December 18, 2013

Serial No. NA3-13-018  
Docket No. 52-017  
COL/BCB

**DOMINION VIRGINIA POWER**  
**NORTH ANNA UNIT 3 COMBINED LICENSE APPLICATION**  
**RESULTS OF RAI REVIEWS**

**Figure 1: Onsite Chemical Storage Locations in Relation to the Unit 3 Control Room HVAC Intake**

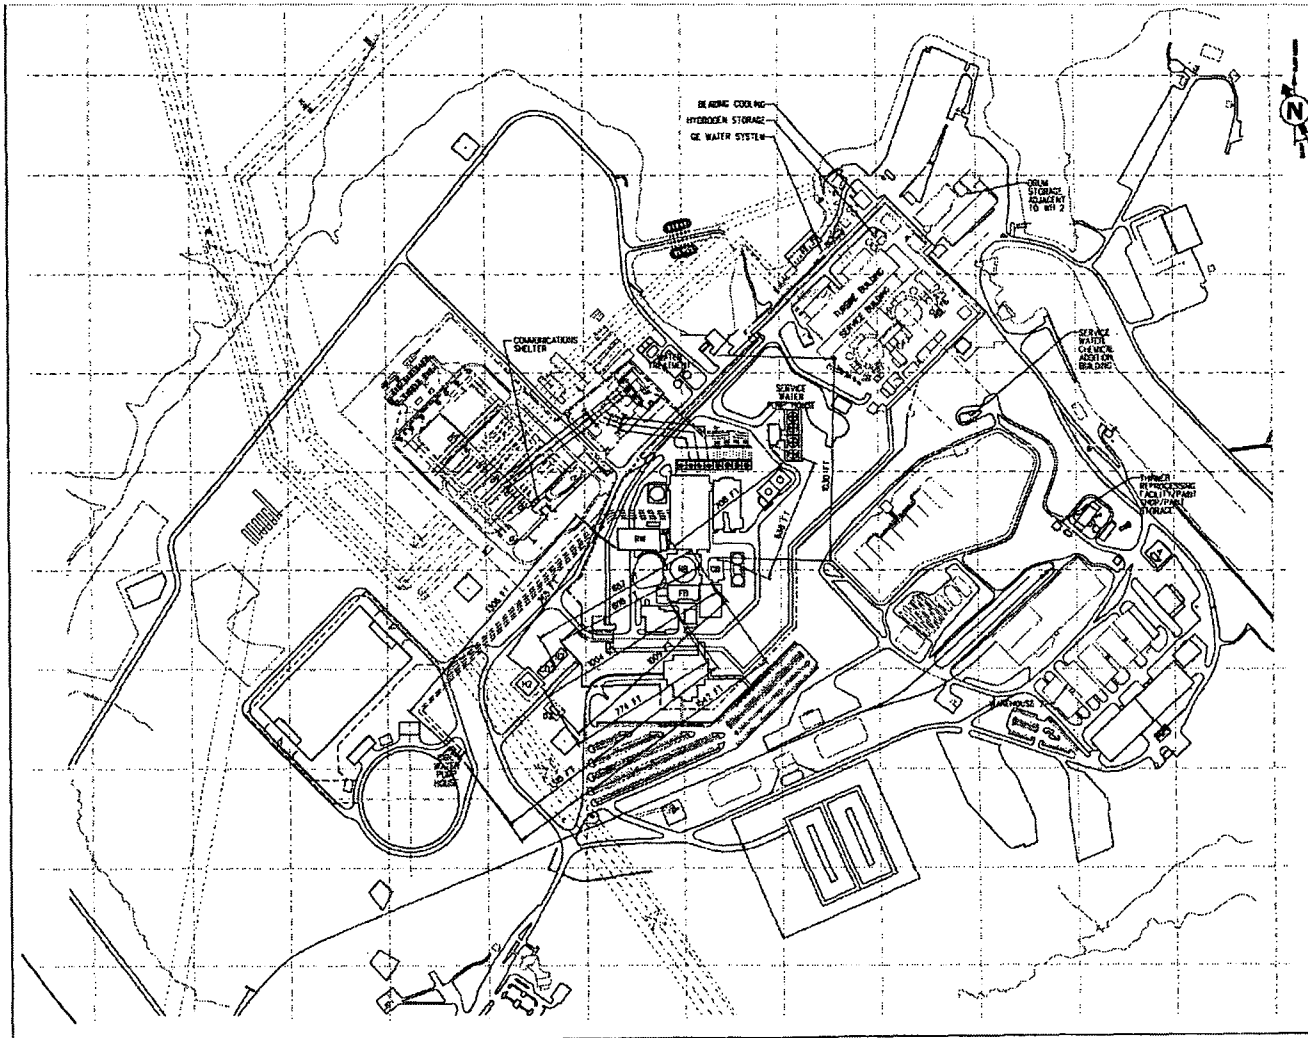
The response to each part follows. Tables 1 through 4 and Figure 1, which are referenced in the response, are provided in Attachments 1 and 2, respectively.

**Figure 1 - Adopted Best Estimate Shear Wave Velocity Profile for RB/FB and CB**

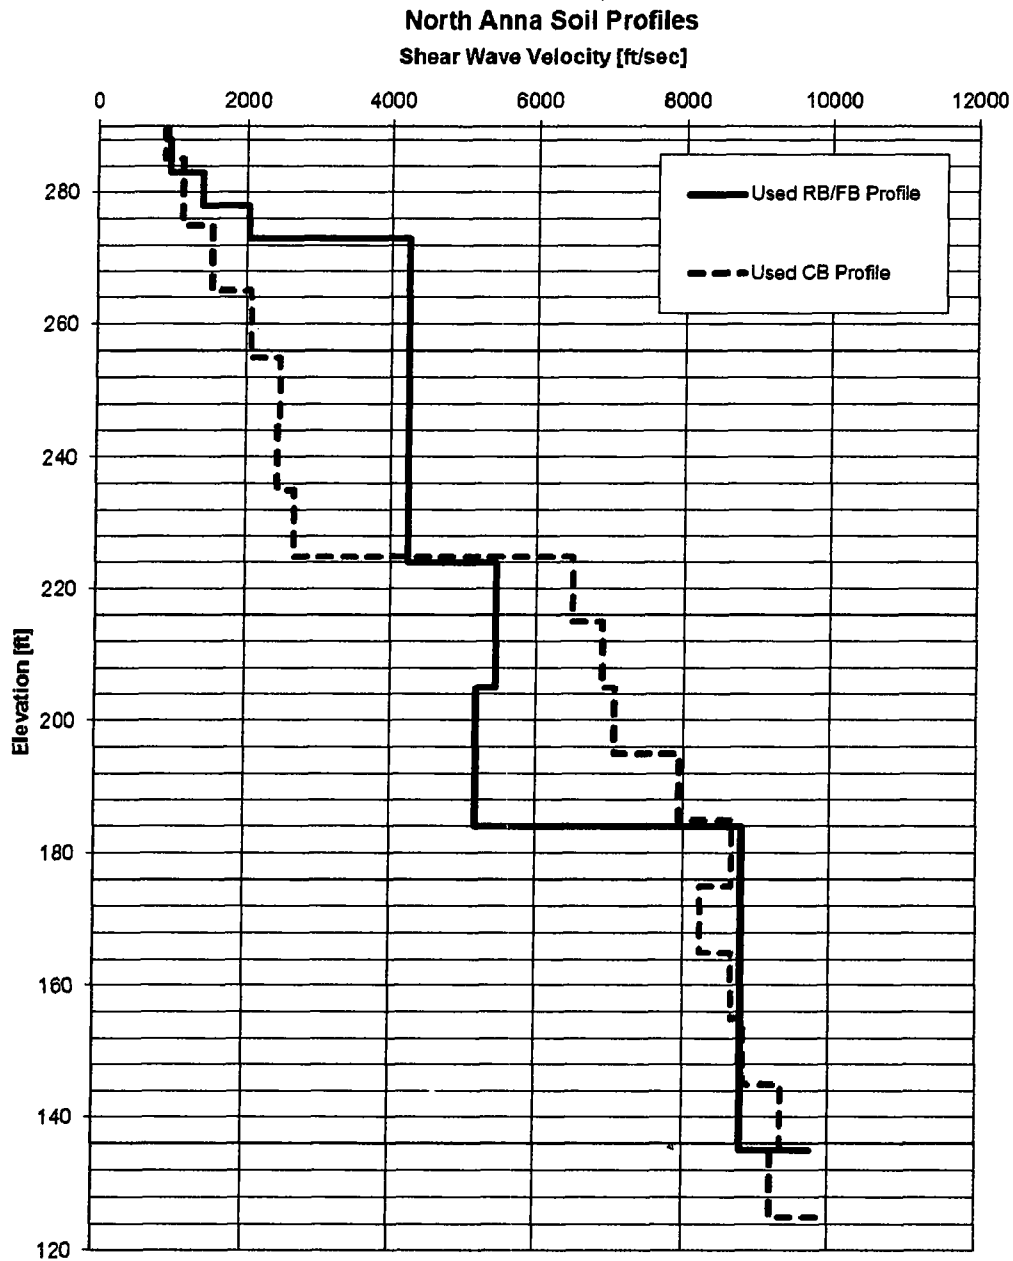
The RB/FB shear wave velocity profile in Figure 1 was obtained from the three  $V_s$  borings within and close to the RB/FB footprint (B-901, B-907 and B-909 in FSAR Figure 2.5.4-242). This figure also shows the best estimate of the shear wave velocity used for the CB which is based on the  $V_s$  profile measured beneath the building (B-909).

**Figure 2 - Shear Wave Velocity for 60 Simulated Profiles for RB/FB**

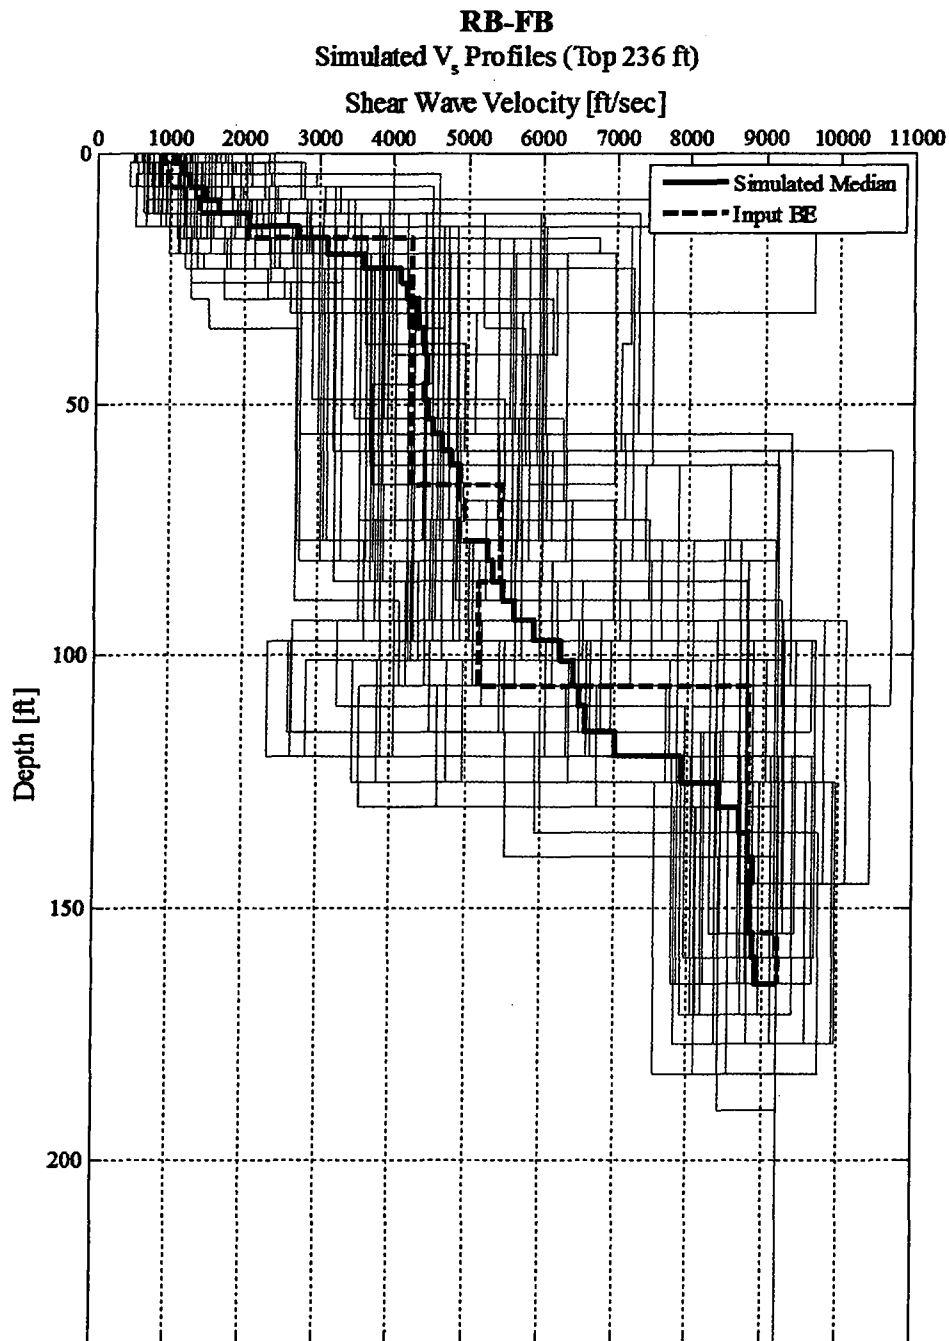
The  $V_s$  profile was varied using a function of the estimated standard deviation for each soil/rock stratum. Figure 2 shows the  $V_s$  for the 60 simulated profiles for the RB/FB, including the input best estimate profile (from Figure 1) and the simulated median. These profiles were used as input to P-SHAKE to generate the FIRS and SSI input motion spectra for the RB/FB.

Figure 3 - Subsurface Cross-Section Profile D-D with Foundation Outline

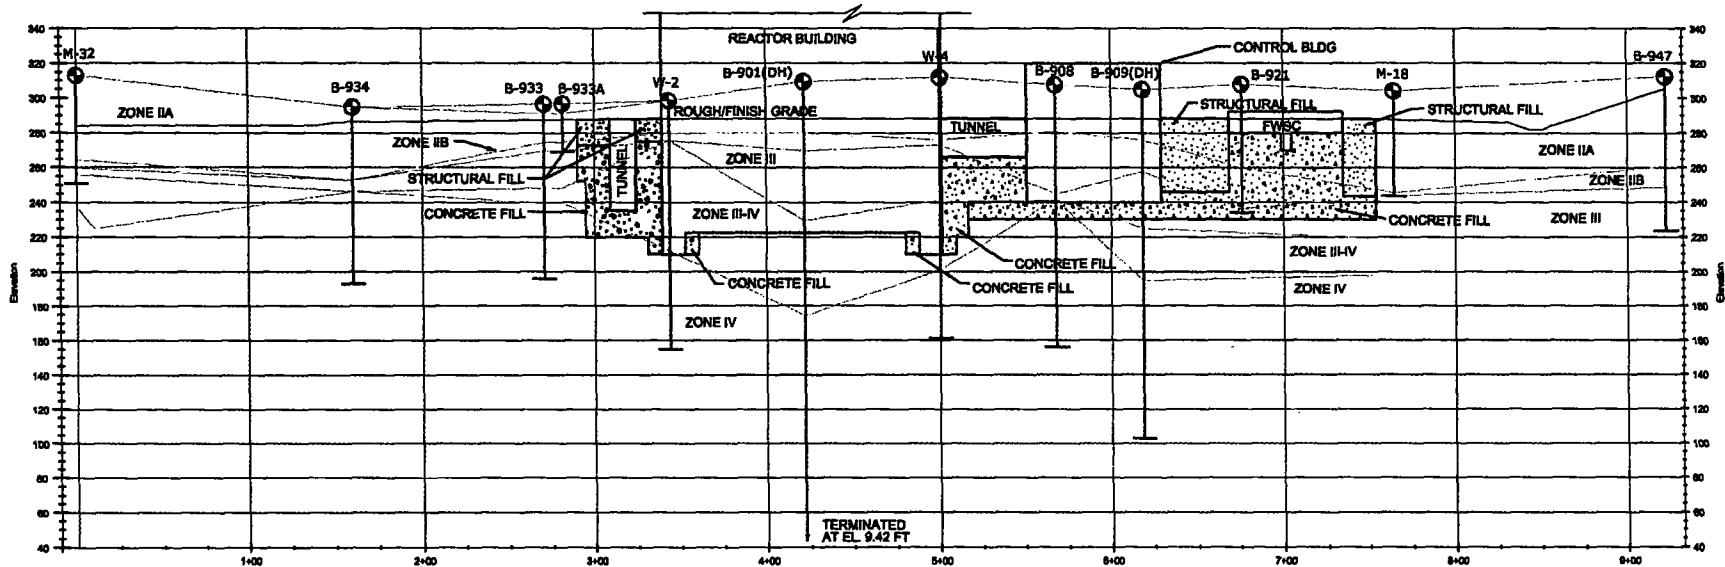
- The variation of Zone III rock thickness from its average value at the RB/FB footprint (161 ft x 230 ft) structure is about 35 ft, i.e., the variation is not large compared to the plan dimensions. (See cross-section profile D-D in Figure 3).

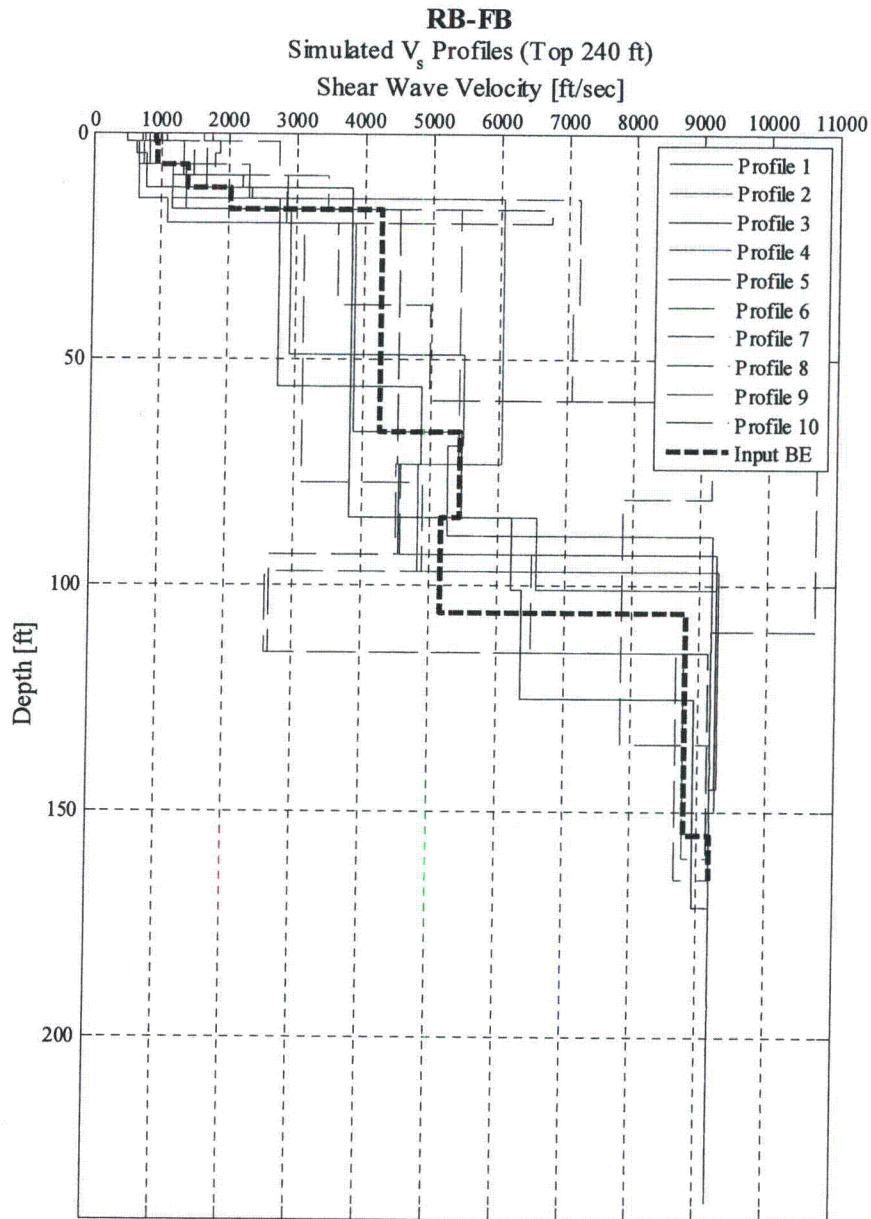
Please provide a table of layer thicknesses, shear-wave velocities, and densities, and identify the type of shear modulus and damping curves used for all site amplification calculations. Also explain how the average shear wave velocity Profiles 1 and 2 displayed in Figure 2.5-241a were developed.

Profiles 1 and 2 are developed as bounding profiles with lower shear wave velocity values corresponding to the more fractured and weathered rock and higher values corresponding to essentially unfractured and unweathered rock observed in boreholes B-901, B-907, and B-909. Profiles 1 and 2 and the  $V_S$  values measured in the three boreholes are shown in FSAR Figure 2.5.4-241. Note that these profiles do not represent any single boring data and are used to identify the range of variation of rock  $V_S$  values.
